## ADDENDUM NO. 1

### San Antonio Water System

Project Name: **Olmos Basin Central Watershed Sewer Relief Line (C-3), Reaches 1 to 4**

Project No.: **08-2512**

SHEET NO. **R/A-101**  
10 OF 123

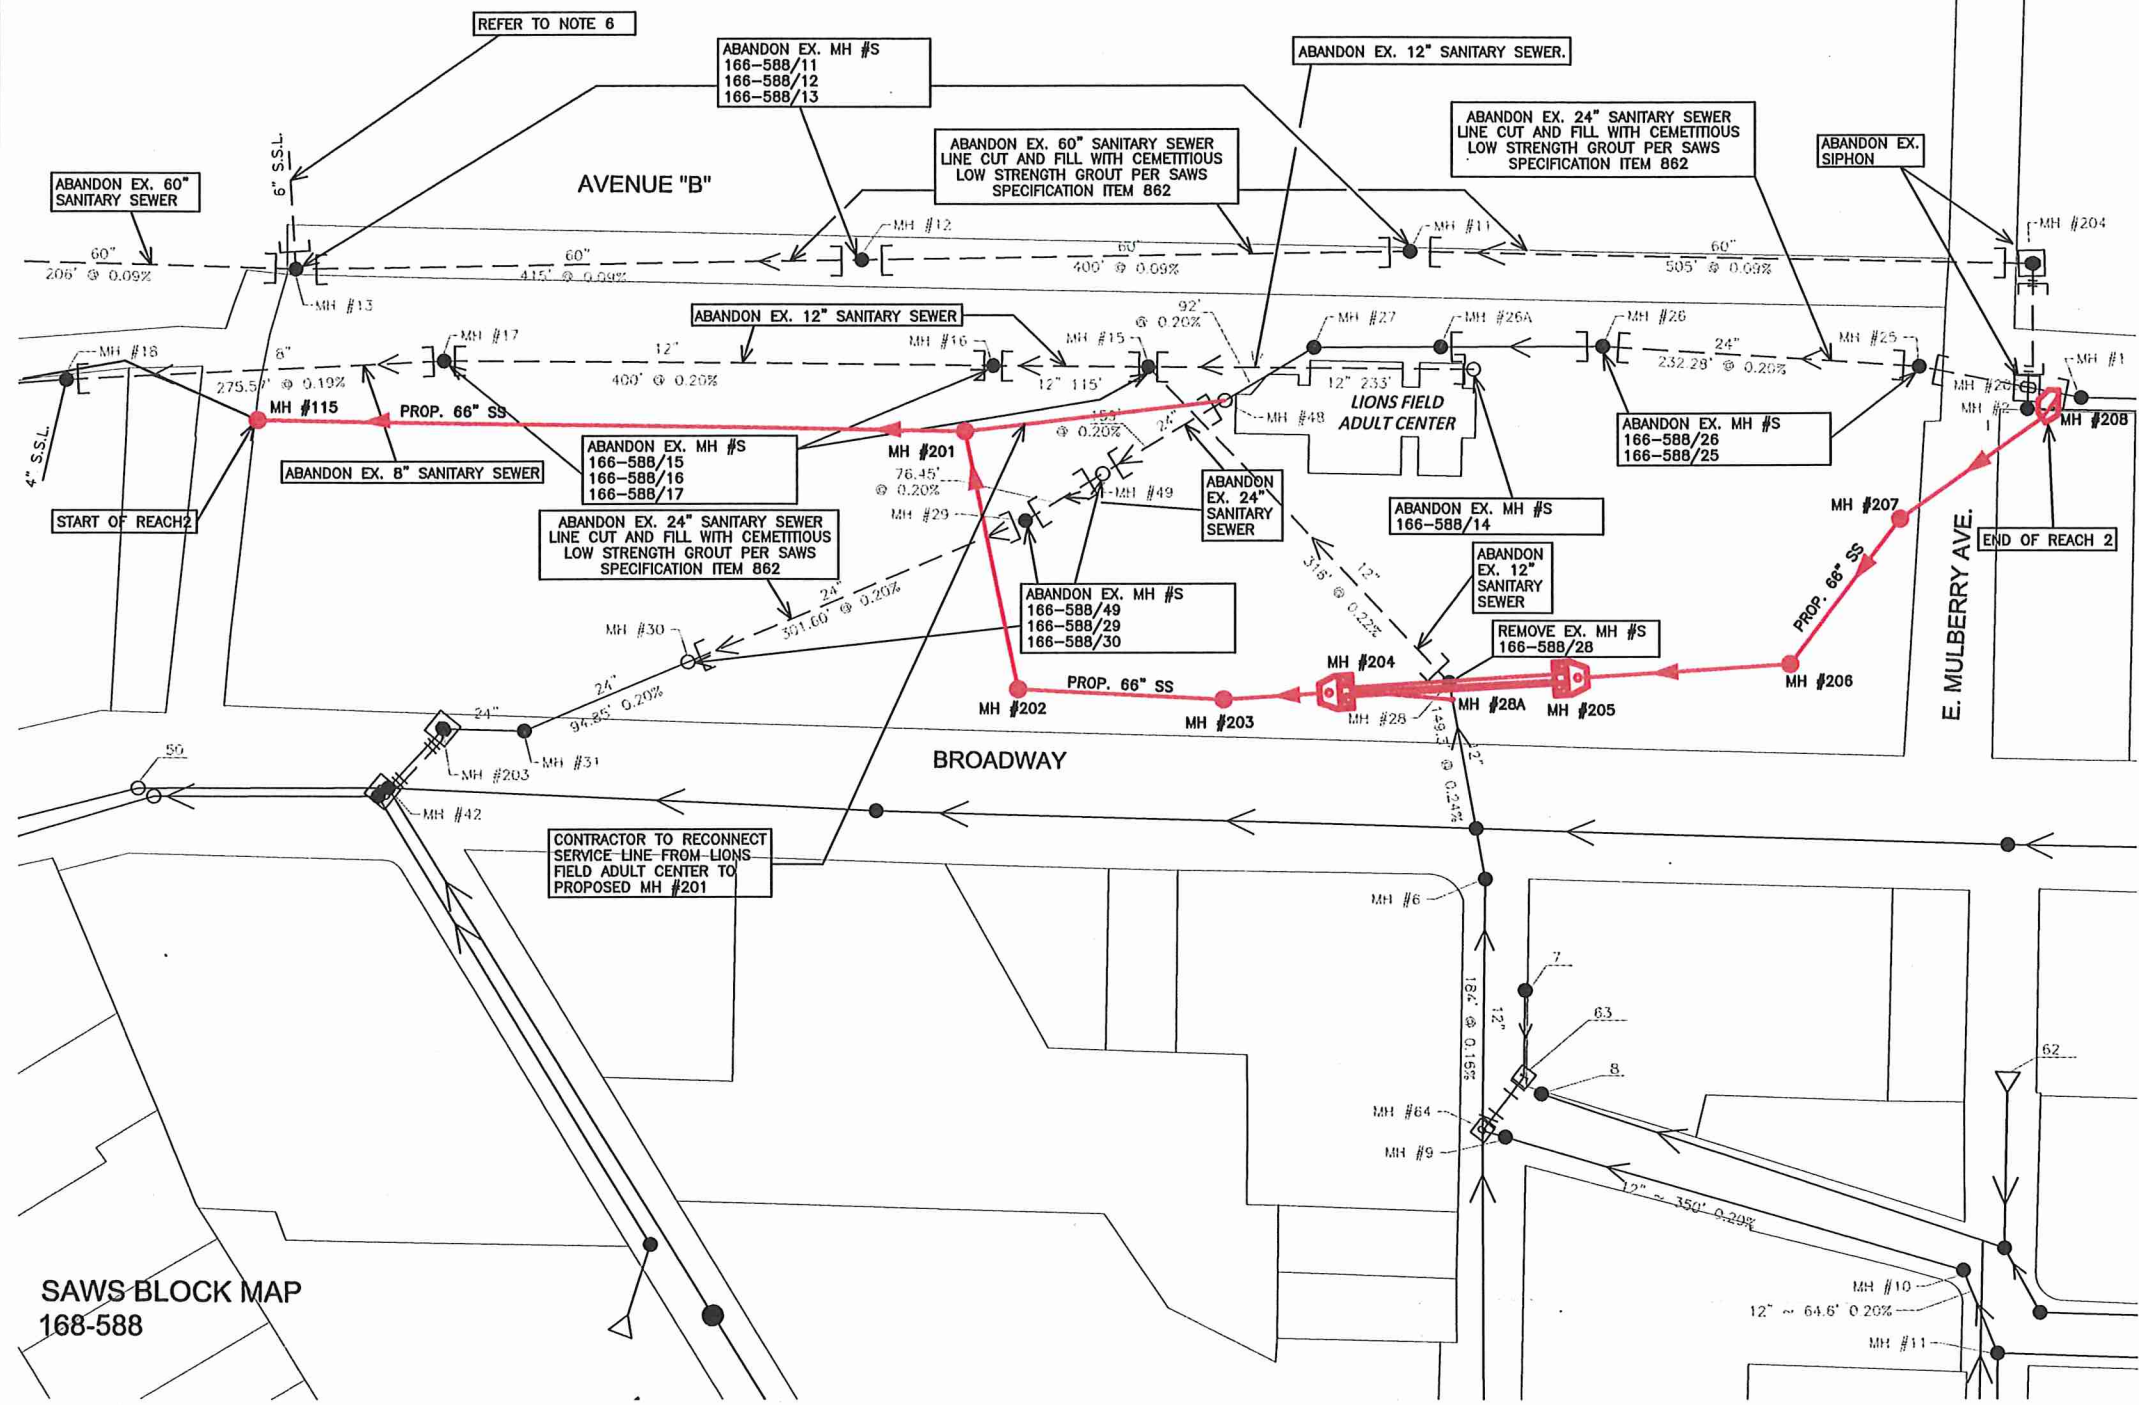
**Q6: Plan Sheets R/A 101, 201 and 301 call for the relocation of utility services. There is no Bid Item for relocating water and gas services to businesses and residences along Ave. B and the Plan Sheets do not identify the location of these services. Can the Owner provide Bidders with the location, quantity, size and type of material for the water and gas services that will be relocated? Will the Owner add Bid Items for water and gas service relocations?**

- Q28: Plan Sheets R/A 101 and 201 identify the abandonment of Manhole No. 166-588-044, Manhole No. 202 and Manhole 166-588-026. We are unable to locate these manholes on the Plan Sheets. Can the Owner provide Bidders with the location of these three manholes?**

*Refer to revised sheets included as part of this addendum. MH 166-588-044 is the siphon box on at intersection of Avenue B and Brackenridge and MH 202 is the siphon inlet box on the golf course on the existing 60” S.S. line. MH 166-588-026 is on 24” sewer located on the Lions Field Adult Center, approx. 250 ft south of Mulberry.*

NOTES	INITIALS	DATE
DESIGNED BY	AH	01/27/12
REVIEWED BY	MRJ	01/27/12
SCALE:	AS SHOWN	
SHEET NO.	R/A-201	
	11 OF 123

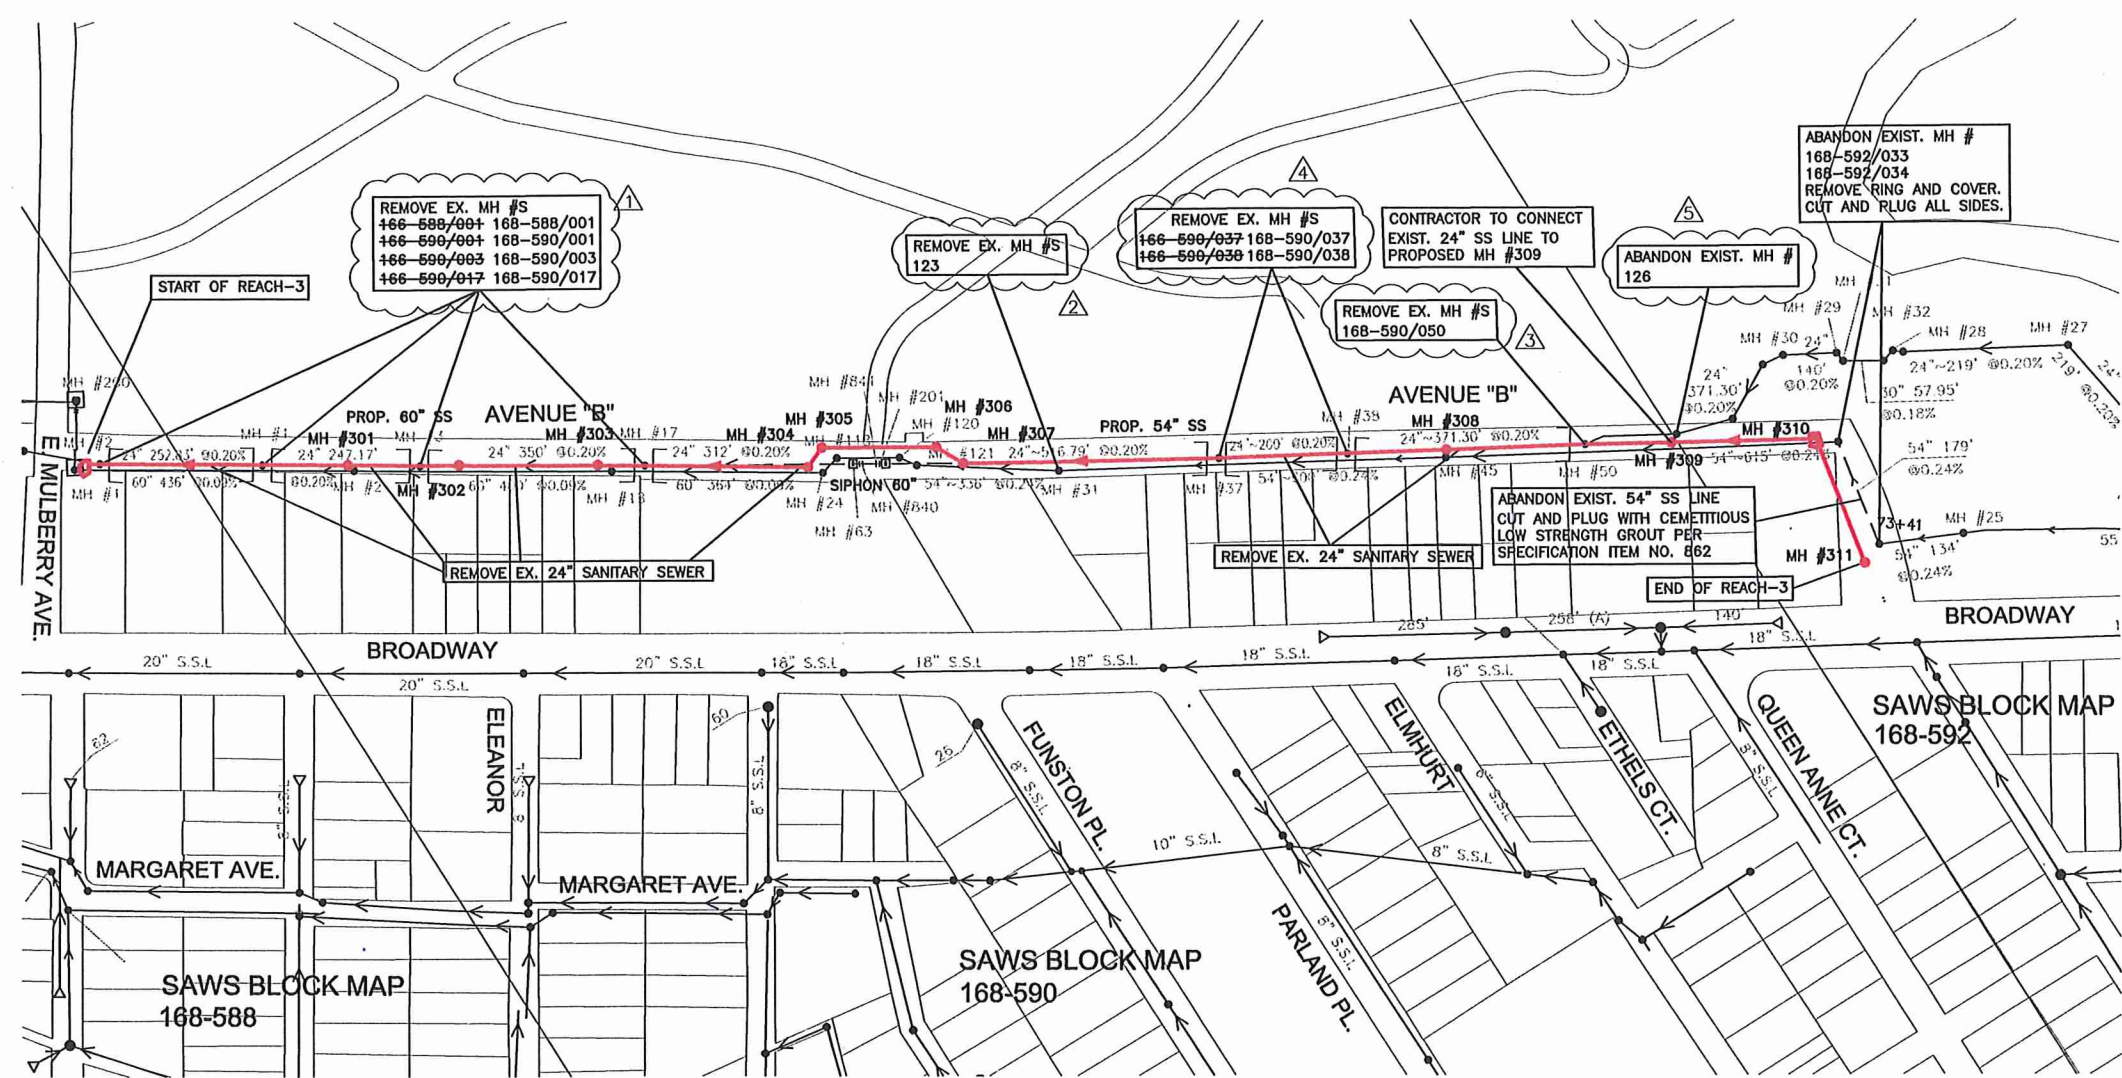
- Q29: Plan Sheet R/A 201 identifies the removal of Manhole No. 168-588-832. We are unable to locate this manhole on the Plan Sheets. Can the Owner provide Bidders with the location of this manhole?**

SHEET NO. **R/A-301**  
12 OF 123

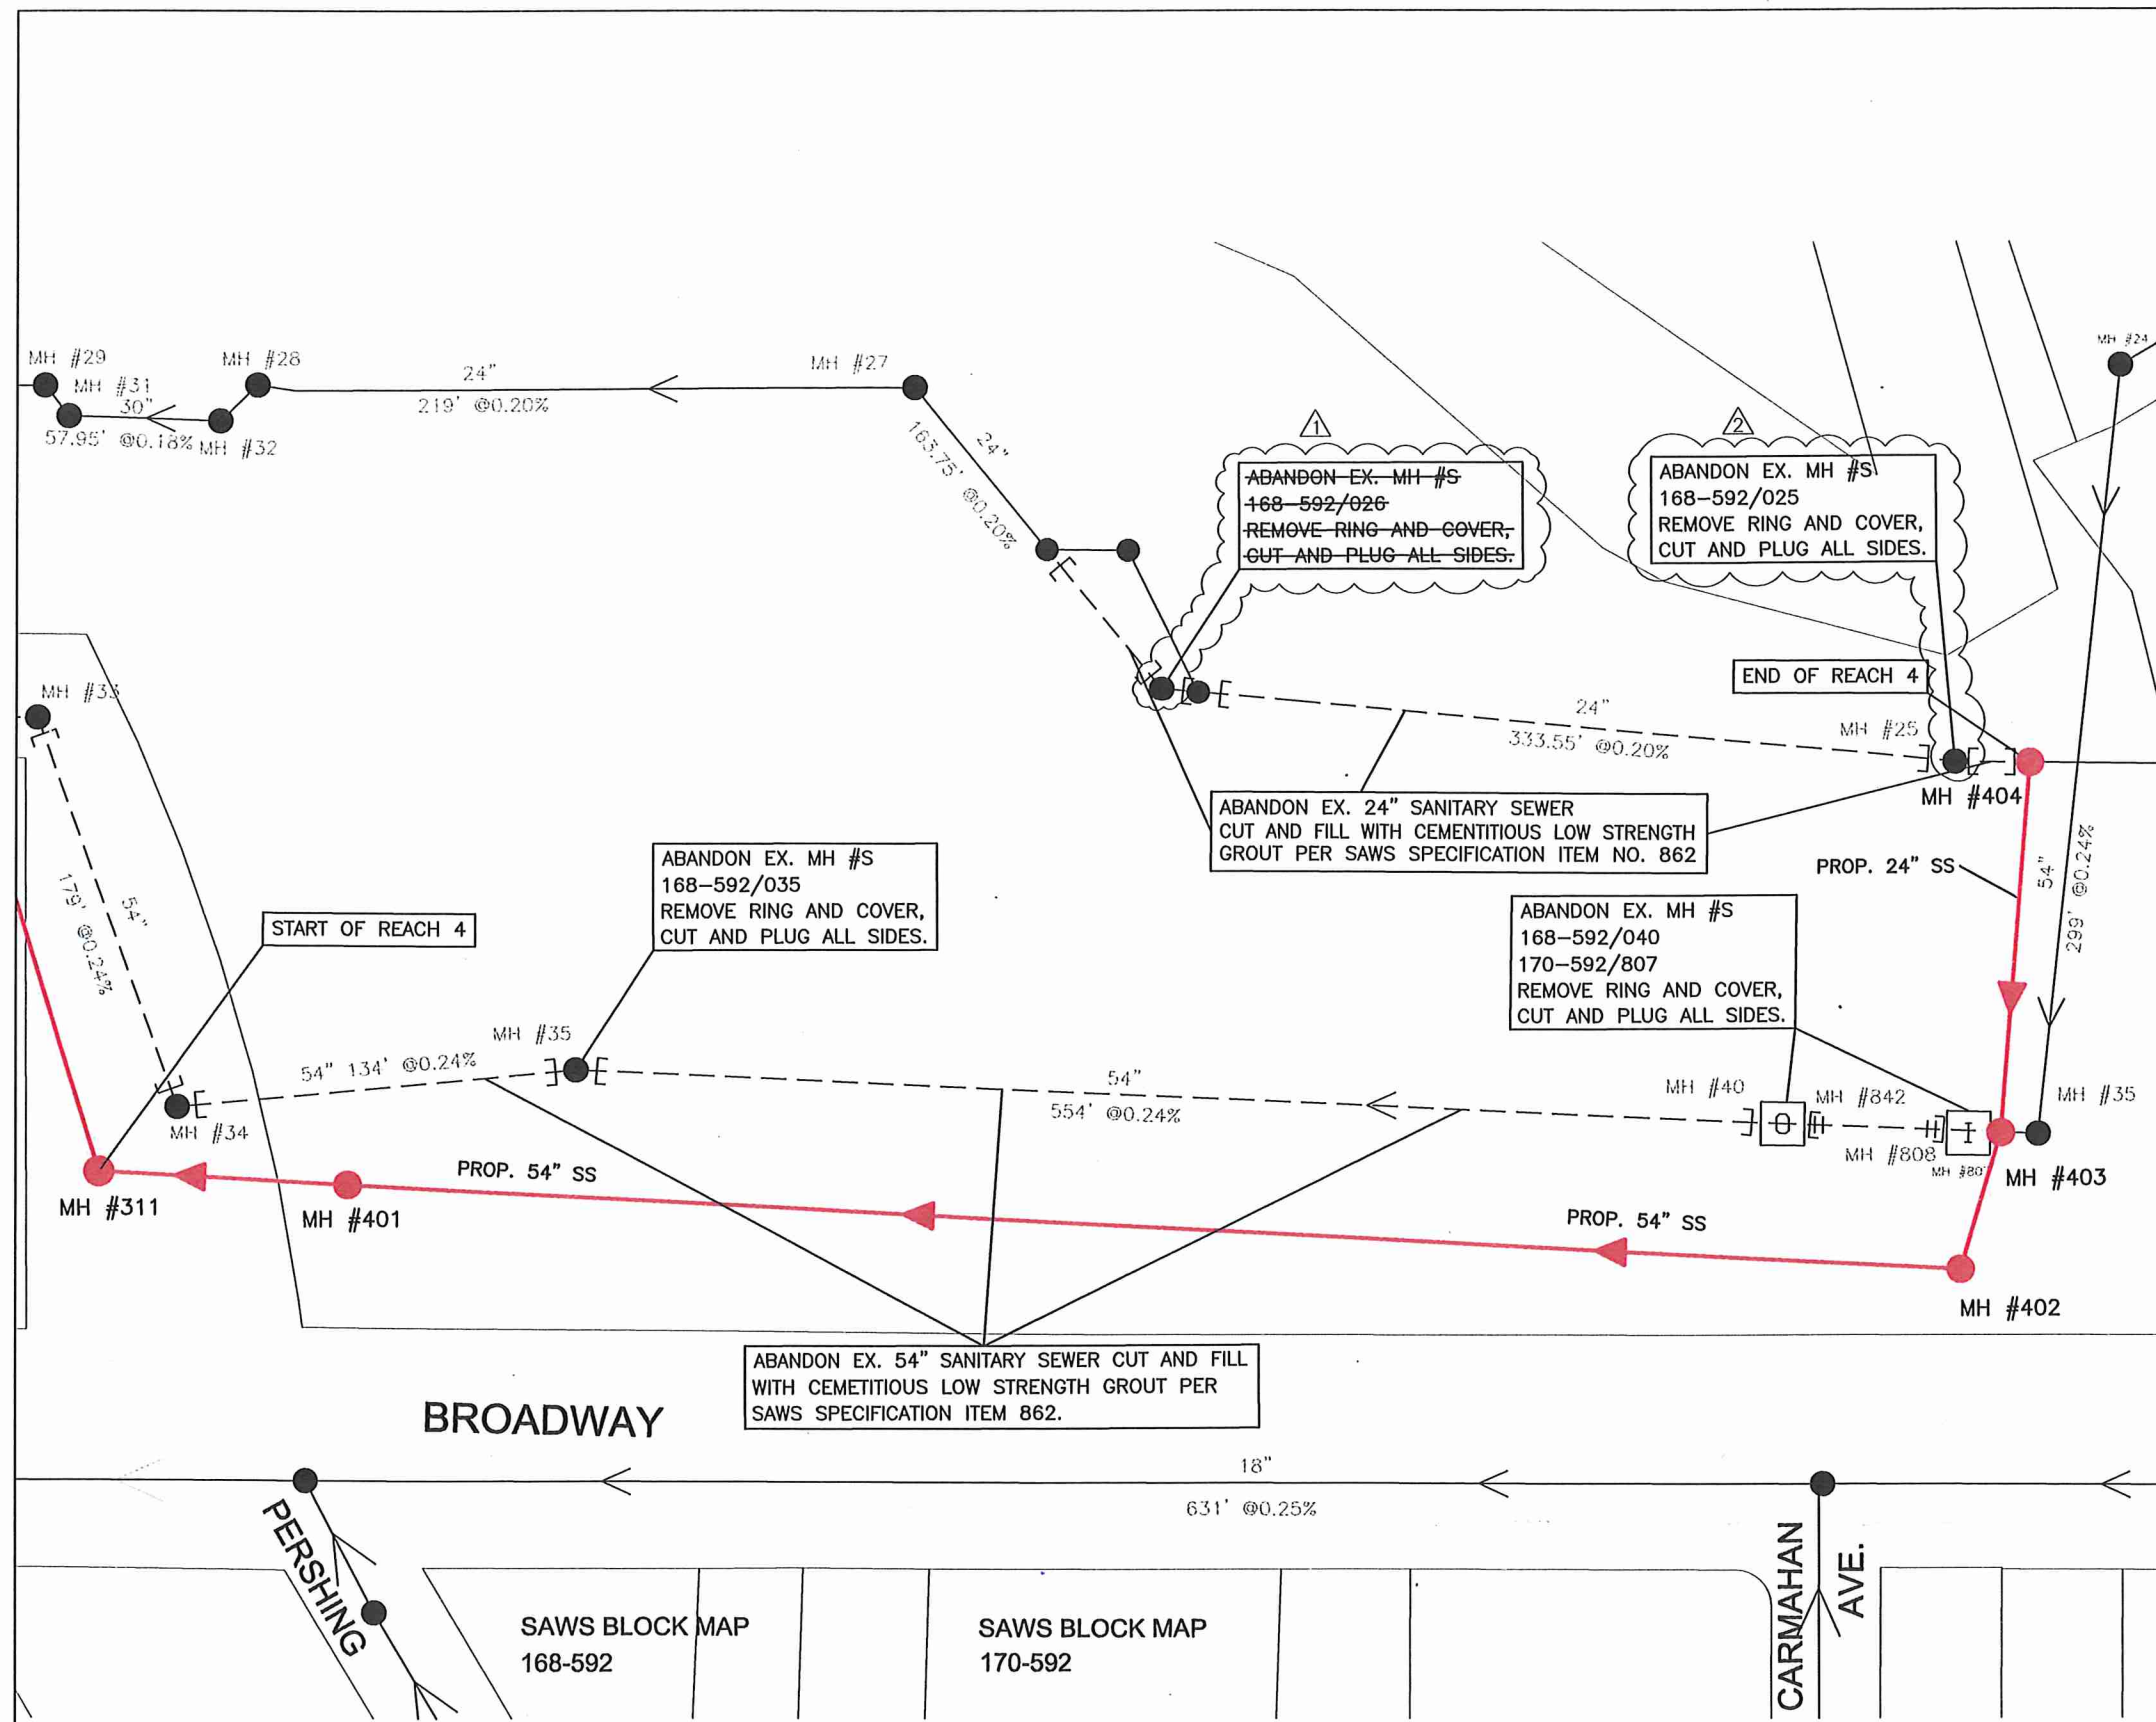
- Q30: On Plan Sheet R/A 301, we are unable to locate Manhole No. 168-590-050 on the Plan Sheets. We are assuming this manhole is to be reconstructed. Is this correct and can the Owner please provide Bidders with the location of this manhole?**

*Refer to revised sheets included as part of this addendum. This manhole is on Avenue B on the 24” S.S. line. This manhole will need to be removed.*

SHEET NO. **R/A-401**  
13 OF 123

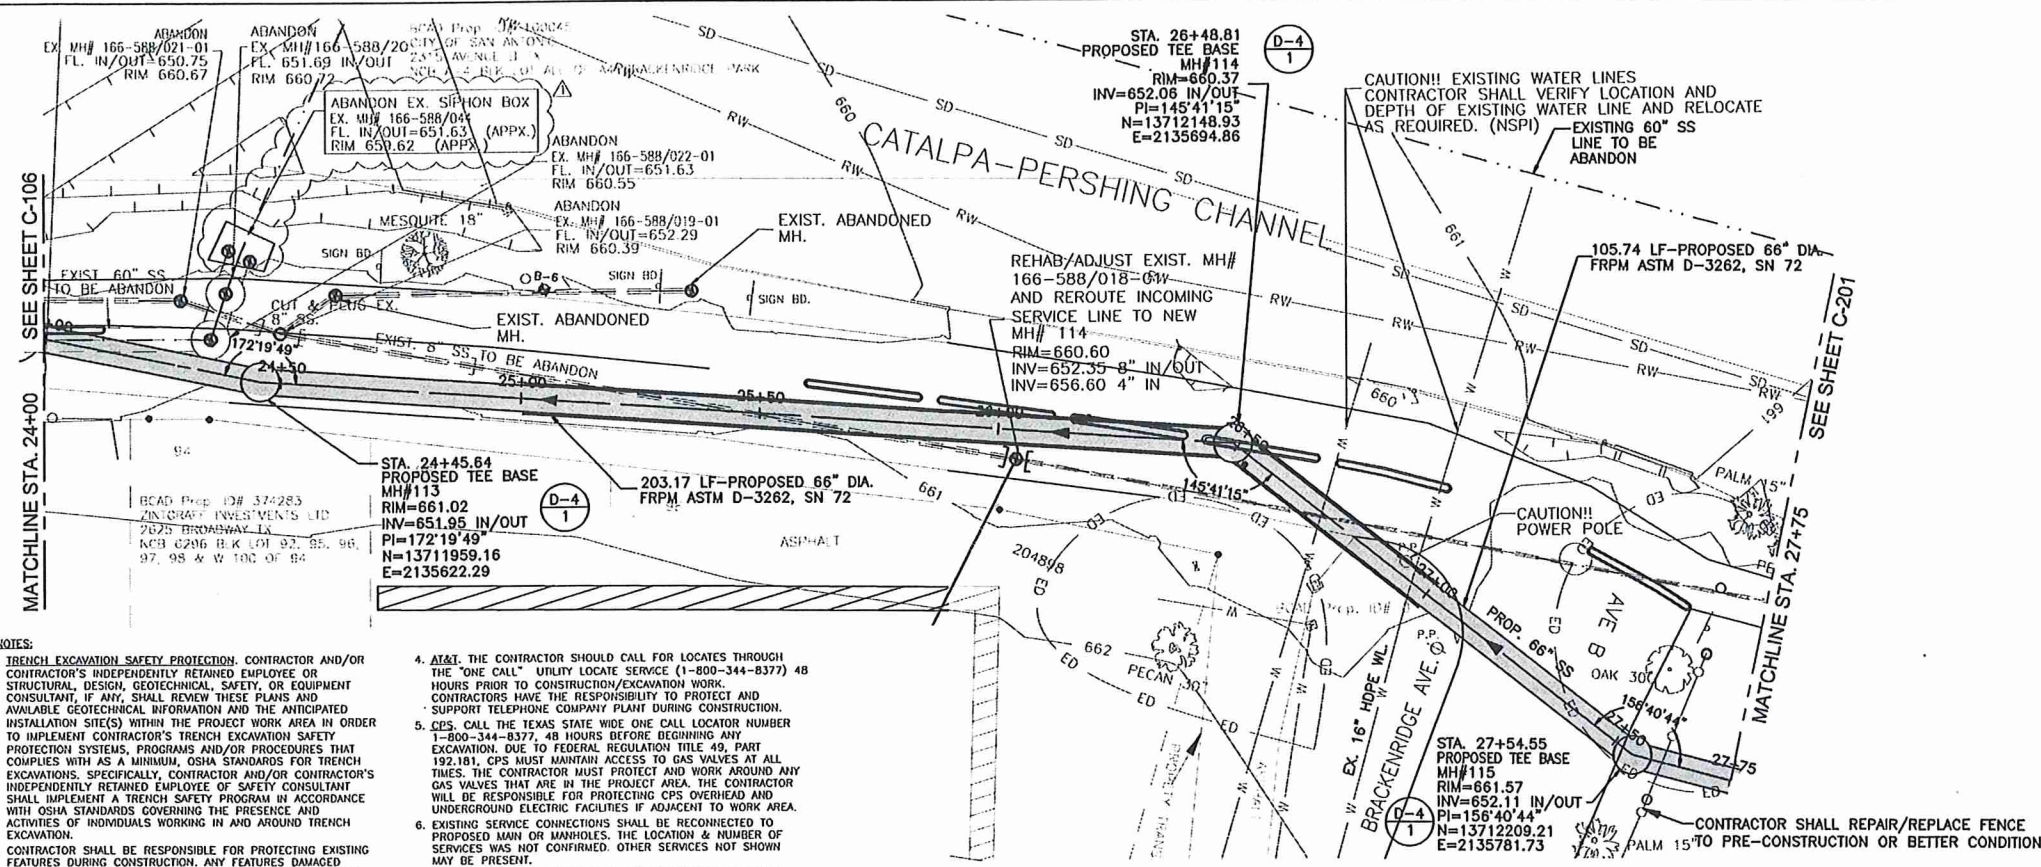
- Q31: Bid Item No. 40 has a quantity of 2 Ea. for Manhole Reconstruction (MH’s 166-588-108 & 166-588-48). Sheet R/A 301 and Sheet R/a 401 also calls for the reconstruction of MH 168-590-050 and MH 168-592-025. It appears there are a total of five manholes to be reconstructed. Is this correct and will Bid Item No. 40 quantity be increased to 5 Ea.?**

**Q34: On Plan Sheet R/A 401, we are unable to locate MH 168-592-026. We are assuming this manhole will not be abandoned. Is this correct?**

*MH 168-590-050 will be removed (refer to Question 30) and MH 168-592-025 will be abandoned in place. Bid item No. 40 quantity to remain as 2 Ea. for the 2 manhole listed in the bid proposal item description. These 2 manholes included in bid item 40 will need to be reconstructed and rehabilitated to accommodate rerouted connections. Refer to referenced sheets C-107 and R/A-201, note 5 and also to revised sheets included as part of this addendum.*
